VALUE ENGINEERING REPORT

**SR 166 Bypass, Widening and Reconstruction
STP00-0021-01(024)(025); PI Nos. 0631300 & 0631310
Carroll County**

May 15, 2013

Georgia Department of Transportation
600 West Peachtree Street
Atlanta, GA 30308

Idea No.: B-5
Client: GDOT
Sheet 2 of 5

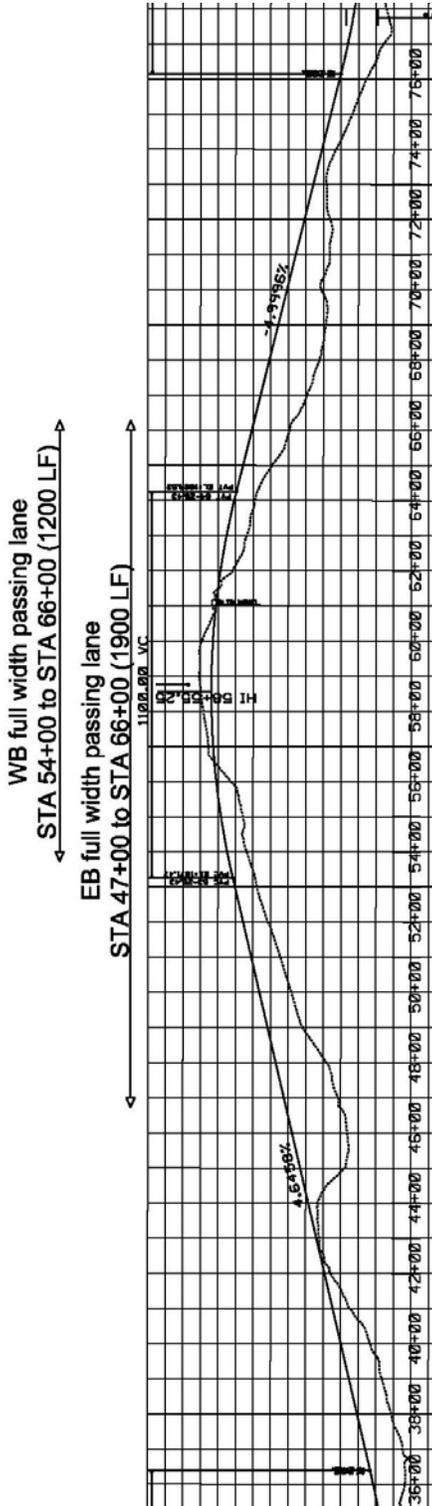
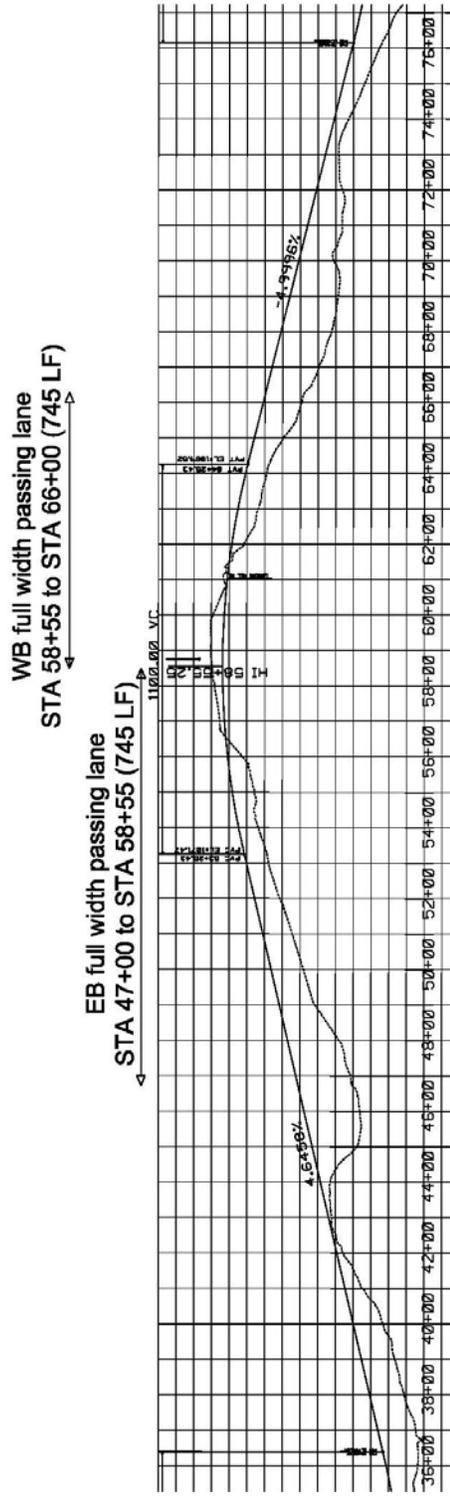
Proposed Change: Review the applicable design criteria for passing lanes and apply as follows: the limits of eastbound full width passing would be from STA 47+00 to STA 55+85 (1155 LF); the widening taper would be 300 LF and the reduction taper would be 660 LF. The limit of westbound full width passing lane is from STA 55+85 to STA 66+00 (745 LF); the widening taper would be 195 LF and the reduction taper would be 660 LF. No change is proposed to the grades or vertical curve as proposed under the original concept. No significant change is made to the widening or reduction taper lengths.

Idea No.: E-1
Client: GDOT
Sheet 2 of 9

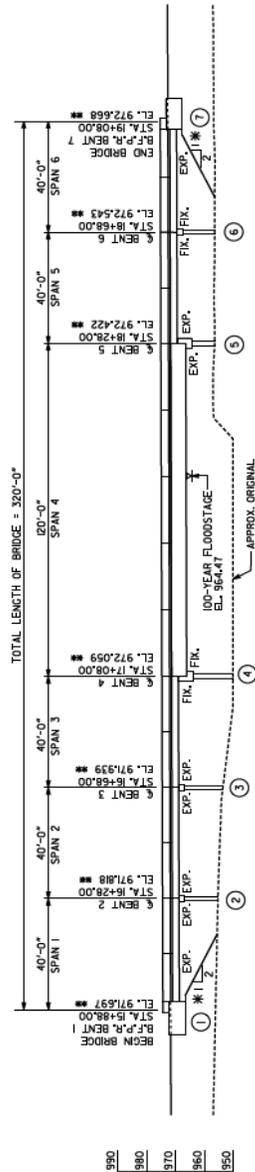
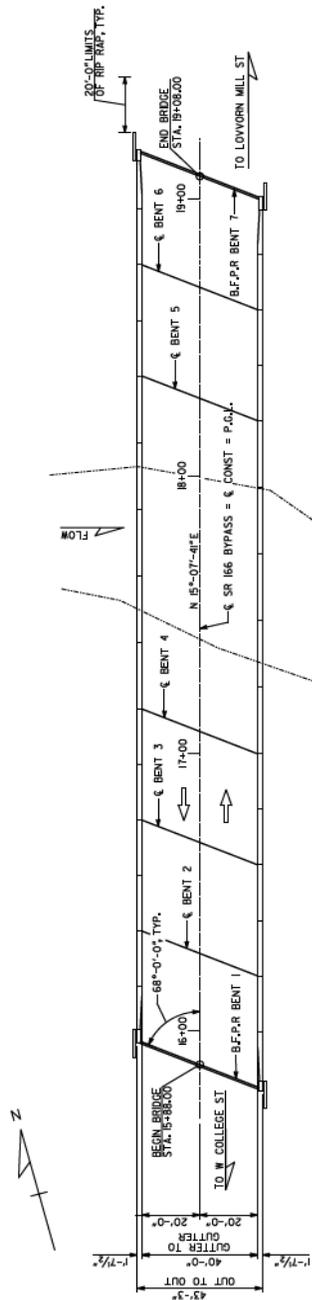
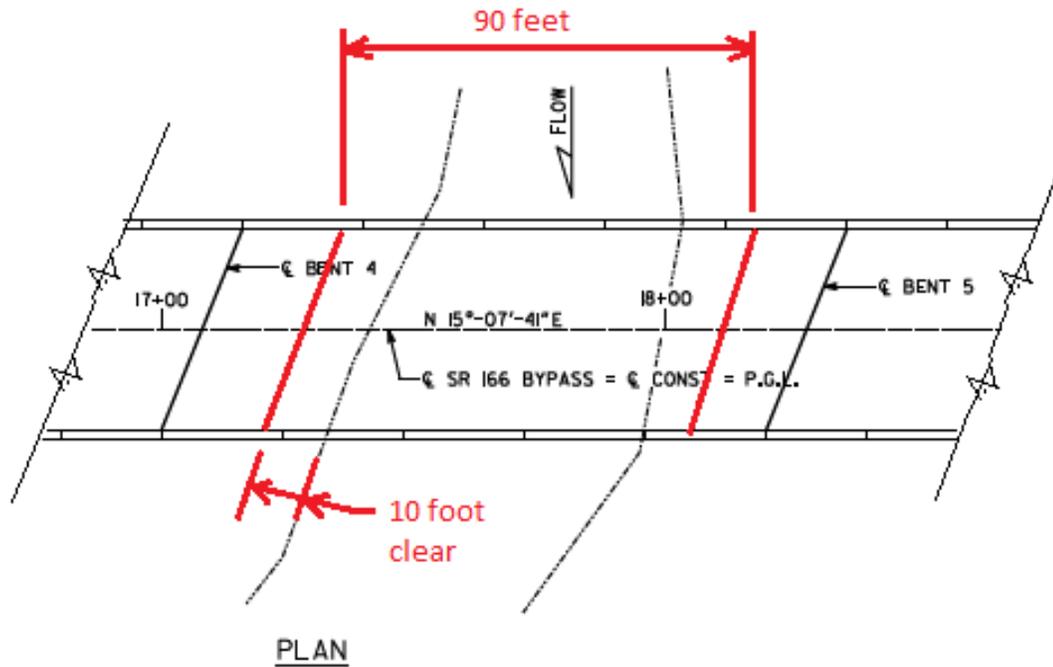
Proposed Change: Use spans (in feet) of 30 – 40 – 40 – 40 – 90 – 40 - 40 = 320 feet. The 90 ft main span will cross the Big Indian Creek stream channel. The beam proposed in this span is a 63” Bulb Tee pre-stressed beam.

Idea No.: E-1
Client: GDOT
Sheet 7 of 9

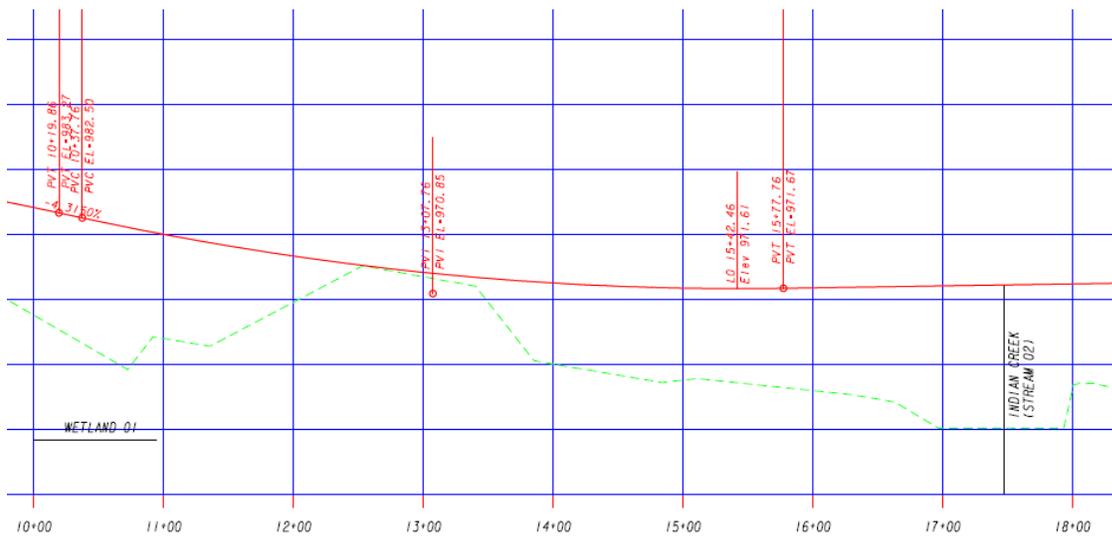
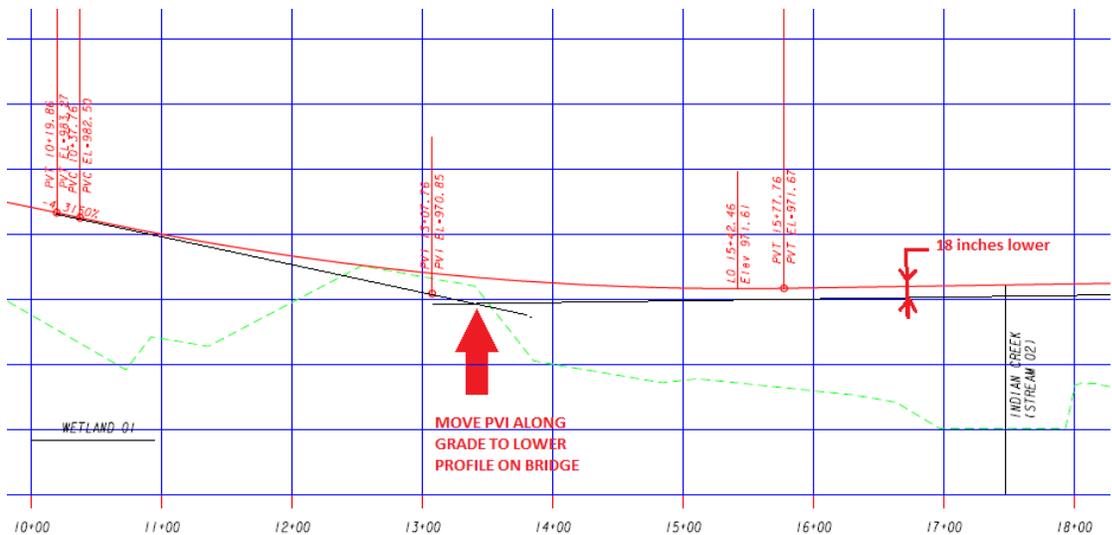
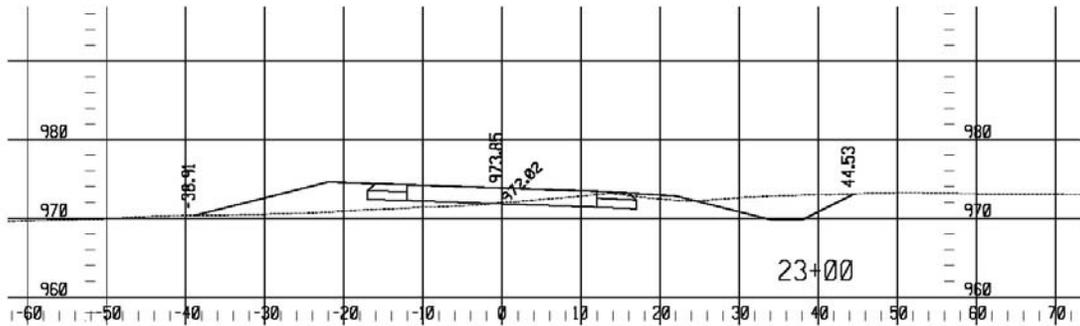
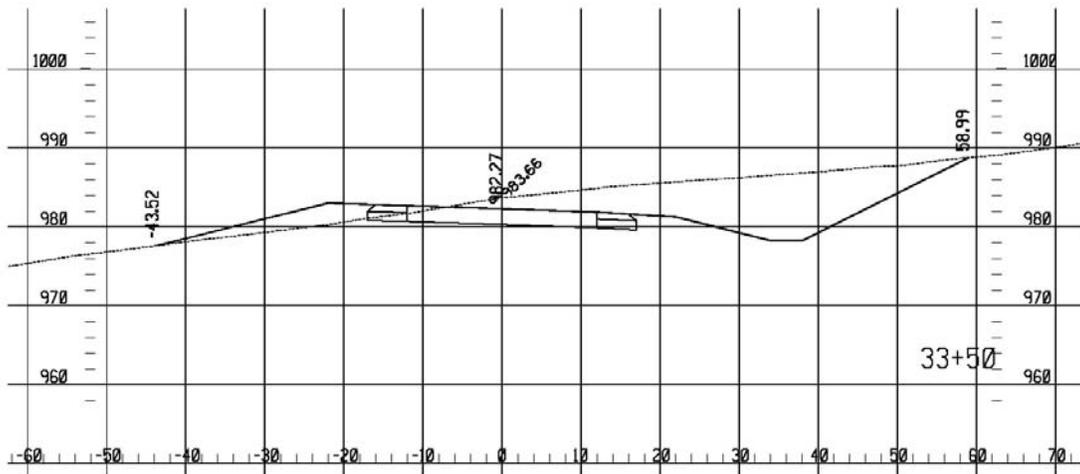
Changes required to the profile are as follows:

Idea No.: H-3a
Client: GDOT
Sheet 2 of 5

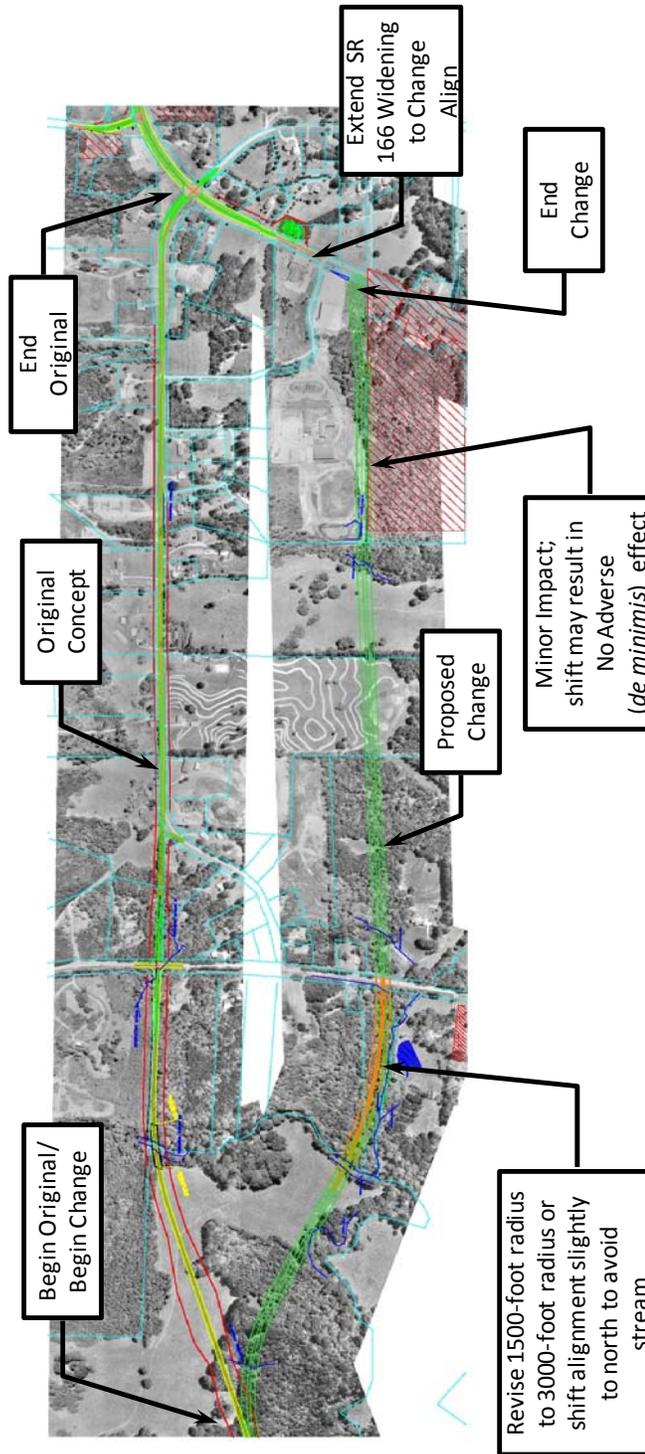
Proposed Change: Use Alternate 2 as shown on the February 28, 2012 PIOH exhibit and referred to as a sub-alternate to the preferred in the Concept Report. Alternate 2 proposes a two-lane rural new location roadway (DS=55 mph) from SR 166 west of Bowdon around the northwest of Bowdon city limits to cross SR 100 approximately 1,650 feet south of the original concept crossing and continue east to tie into existing SR 166 north of Bowdon and approximately 1,350 feet south of the original concept. The primary driver for consideration of this recommendation is to improve the operations between the W. and N. Jonesville Road intersections. This analysis and cost summary does not include any damages that could be required to the gas station between the 2 intersections.

Justification: Alternate 2 was removed from consideration because of concerns for adverse 4(f) impacts to a potentially historic resource located at the proposed intersection of the bypass with SR 166 north of Bowdon. Based on information provided, it appears that this alignment is a viable option. It appears the alignment could be designed such that any required acquisition from the eligible resource would result in a No Adverse Effect (*de minimis*) determination. Utilizing Alternate 2 would provide additional 1,300 feet of intersection separation from N. Jonesville Road, thereby significantly improving the operations at that area. Using Alternate 2 would eliminate the 45 mph truck bypass through a highly residential area along an existing 40 mph rural local W. Jonesville Road. By removing the re-use of this section of W. Jonesville Road, there will be improvements and efficiencies to the MOT for this area also. Increasing the radius west of the SR 100 intersection to 3000 feet should eliminate longitudinal impacts to the perennial stream.

Idea No.: H-3b
Client: GDOT
Sheet 2 of 5

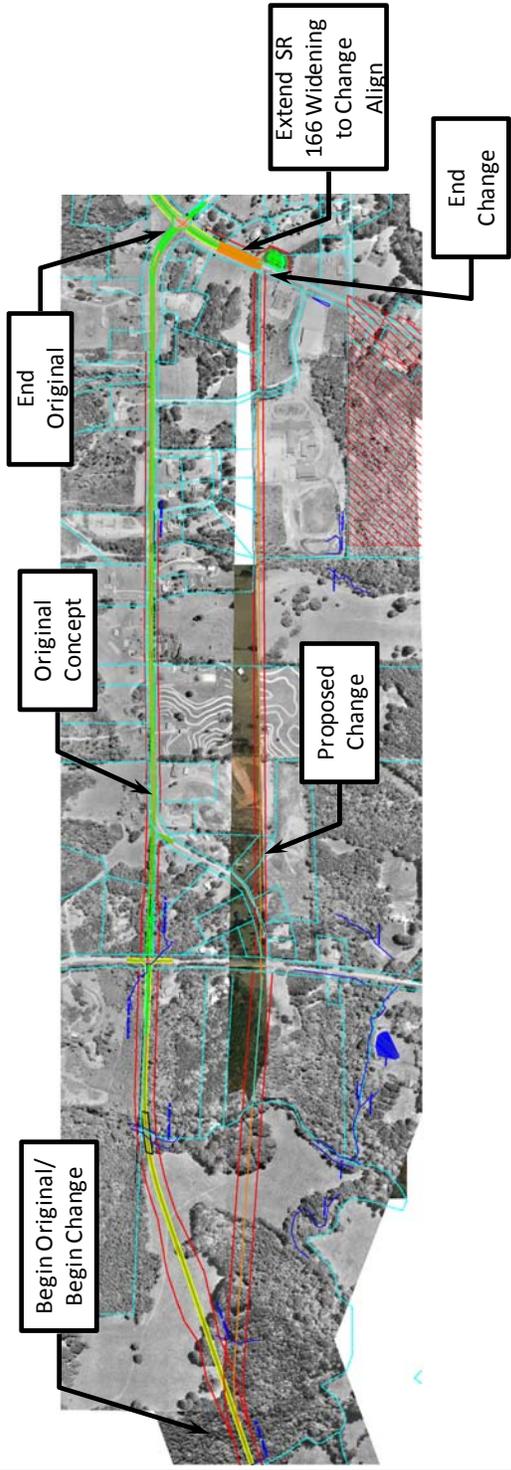
Proposed Change: Use a variation, as shown on the following sketch, of Alternate 2 as shown on the February 28, 2012 PIOH exhibit that crosses SR 100 approximately 870 feet south of the original concept. Alternate 2 proposes a two-lane rural new location roadway (DS=55 mph) from SR 166 west of Bowdon around the northwest of Bowdon city limits to cross SR 100 approximately 750 feet south of the original concept crossing and continue east to tie into existing SR 166 north of Bowdon and approximately 675 feet south of the original concept. The primary driver for consideration of this recommendation is to improve the operations between the W. and N. Jonesville Road intersections. This analysis and cost summary does not include any damages that could be required to the gas station between the 2 intersections.

Justification: Based on information provided, it appears that this alignment is a viable option. It would eliminate the 4(f) concerns with the previously considered Alternate 2 and would provide an additional 675 feet of intersection separation from N. Jonesville Road. Using this alternate would eliminate the 45 mph truck bypass through a highly residential area along existing 40 mph rural local W. Jonesville Road. By removing the re-use of this section of W. Jonesville Road, there will be improvements and efficiencies to the MOT for this area also.

Idea No.: E-3a
Client: GDOT
Sheet 2 of 5

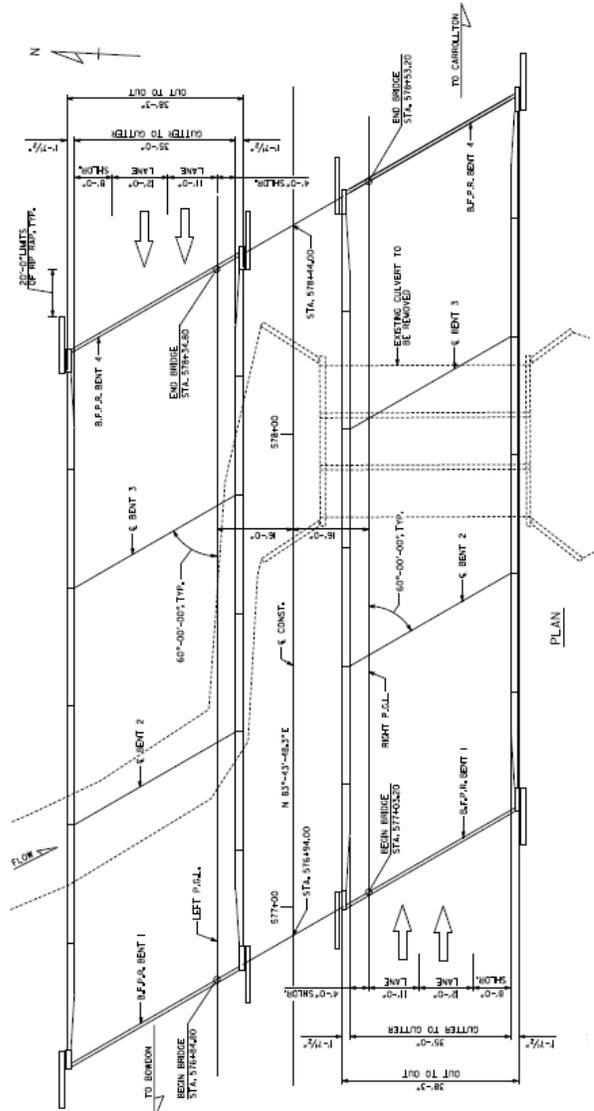
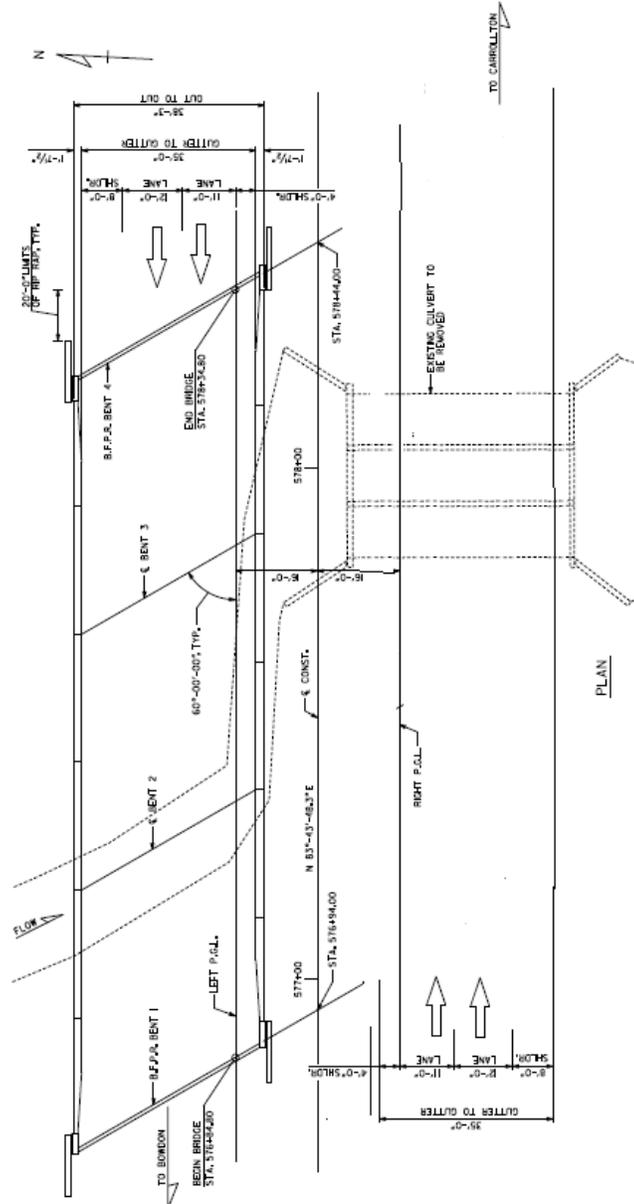
Proposed Change: Retain the existing culvert and construct only the westbound bridge

Idea No.: E-3b
Client: GDOT
Sheet 2 of 5

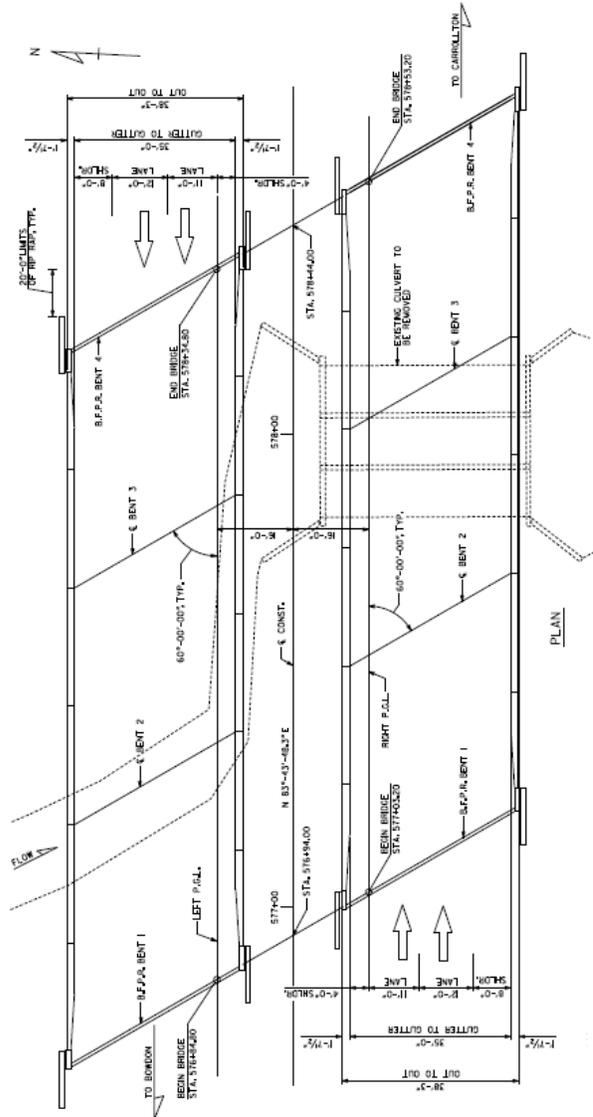
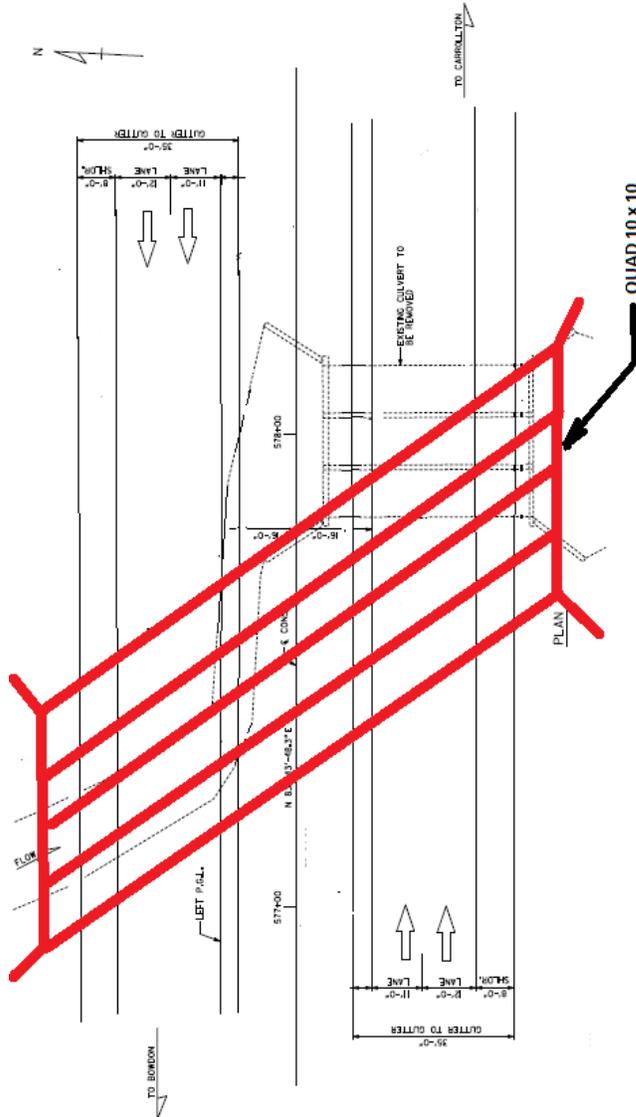
Original Concept: The current plans show 2 new parallel bridges over Garrett Creek. Each bridge is composed of three, 50 ft spans.

Proposed Change: Remove the existing culvert completely and construct a new culvert along the skew of the original stream alignment.
